To all customers of the EPIC® H-A 3 product series

24 June 2026

Product Change Notice: Material Change of Locking Lever - EPIC® H-A 3 Series

EPIC® H-A 3 housing - old version (left) with a metal locking lever and new version (right) with a plastic locking lever. Using a cable coupler hood as an example (example image)

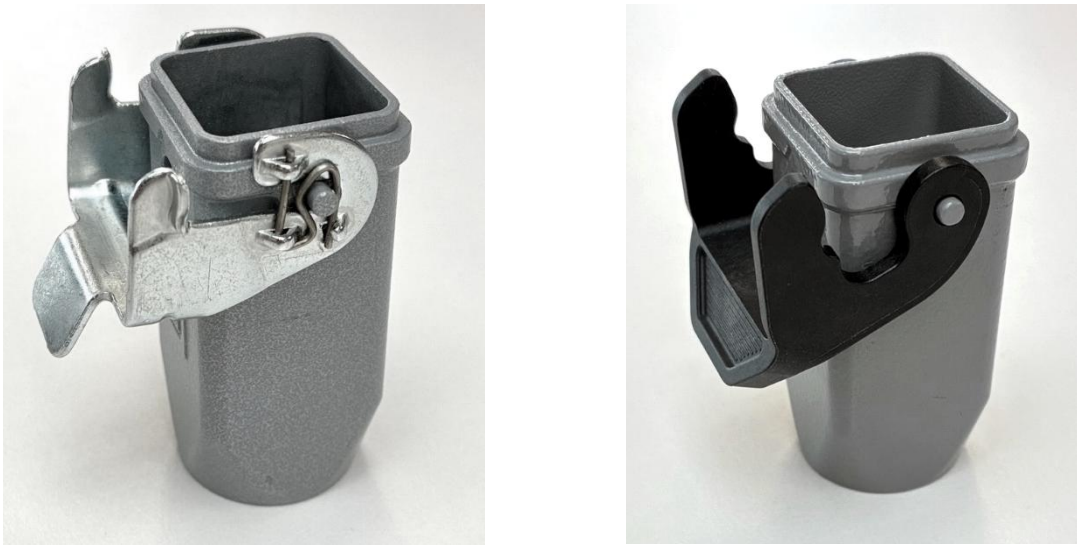
As part of our ongoing product optimization, the locking lever used on selected **EPIC® H-A 3 rectangular connector housings** have been redesigned and will be manufactured from plastic rather than metal going forward. **The technical properties specified in the catalog remain unchanged.**

During the redesign, particular attention was paid to maintaining the existing functional characteristics while improving handling and reducing weight. The updated locking lever design is also aligned with the current design language of the EPIC® rectangular connector portfolio.

The new locking lever will also be made **available as a separate spare part** for the affected housings under **part number 7433510817**. The housings themselves remain unchanged. Only the locking lever is affected by this material change.
